Subject: Reconsideration of Final Record Plat PLT2004-00433 - 202 Martins Lane – Prather Subdivision

**CITY OF ROCKVILLE PLANNING DIVISION  
STAFF REPORT AND RECOMMENDATION**

**FINAL RECORD PLATS:** Lots 1 and 12,  
Prather Subdivision

**APPLICATION NUMBERS:** PLT2004-00433

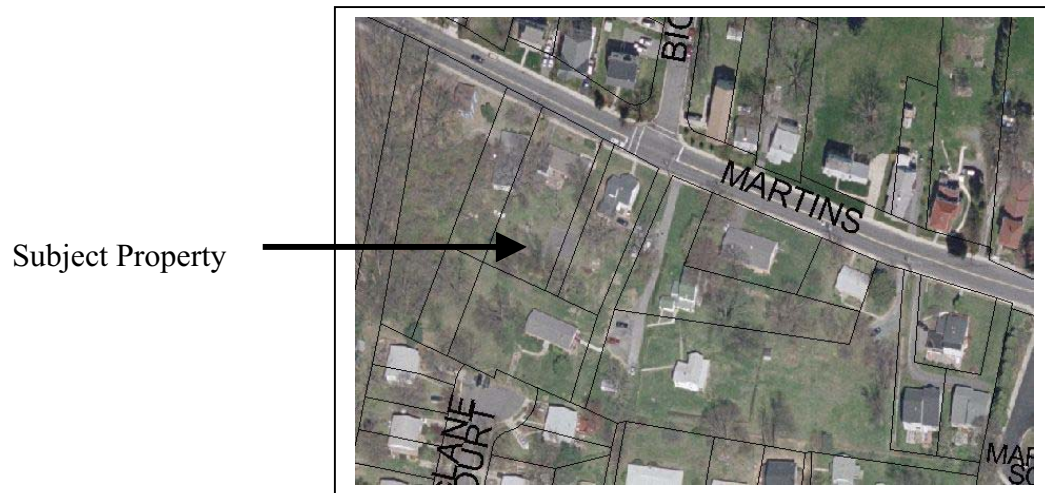
Section 25-749(b) requires that any resubdivision within an existing residential area to maintain, to the extent feasible, the average area and frontage of lots within five hundred (500) feet. An assessment was done of the residential lots within five hundred feet of the proposed lots. Non-residential properties, like the Municipal Swim Center and the Rock Terrace school were not included because they would have skewed the assessment and are not really part of the neighborhood. The lots vary significantly in size, both in area and frontage. If all residential parcels are included in the calculation, the average area is 11,205 square feet and average frontage is 58 feet. When seven large residential properties are excluded, the average lot size drops from 11,205 square feet to 8,768 square feet. The average frontage drops from 58 to 54 feet. It is also important to note that the smallest lot contains 4,001 square feet and the shortest street frontage is 20 feet. There is, in fact, one property that has no street frontage at all, again typical of generational development which often formed family compounds.

There are three recorded pipestem lots within the five hundred foot assessment area, two on the same side of the street and one across the street but there are two houses located behind the ones on Martins Lane that give the appearance of more pipestem lots.

It is not possible in this eclectic area to come up with an average area or frontage that accurately reflects the neighborhood. Since the proposed lots contain 6,052 square feet of land and 8,076 square feet of land with 62.33 feet and 20.70 square feet of frontage, the proposed subdivision meets the standards of the R-60 zone. The proposal for a pipestem lot is also compatible with the immediate area of the property. In this neighborhood, where irregular lots and street frontage are the norm, forcing the new subdivision to conform is not the most feasible and is not consistent with the generational character aspect of the neighborhood. As a result, it is felt that the proposed subdivision maintains, to the extent feasible, the average area and frontage of lots within five hundred feet and reflects the existing uneven development pattern.

**STAFF RECOMMENDATION:** Approval, subject to the conditions noted below:

1. That the plat be revised to make modifications/additions as identified on Planning Commission Exhibit "A" (in the Planning Division file) and resubmitted to the Planning Division for recordation. The final plat submission should include the original mylar plat, five mylar copies and two paper copies;
2. That the existing house be demolished prior to recordation of the plat;
3. That shared access to the properties be provided within an ingress/egress easement within the pipestem on Lot 2;
4. That the applicant work with historic preservation staff in an attempt to place houses on the lots that are compatible with the surrounding properties; and
5. That the final corrected Plat be submitted in an appropriate electronic format as specified in Section 25-782(c), (d) and (e) of the Rockville Zoning Ordinance.
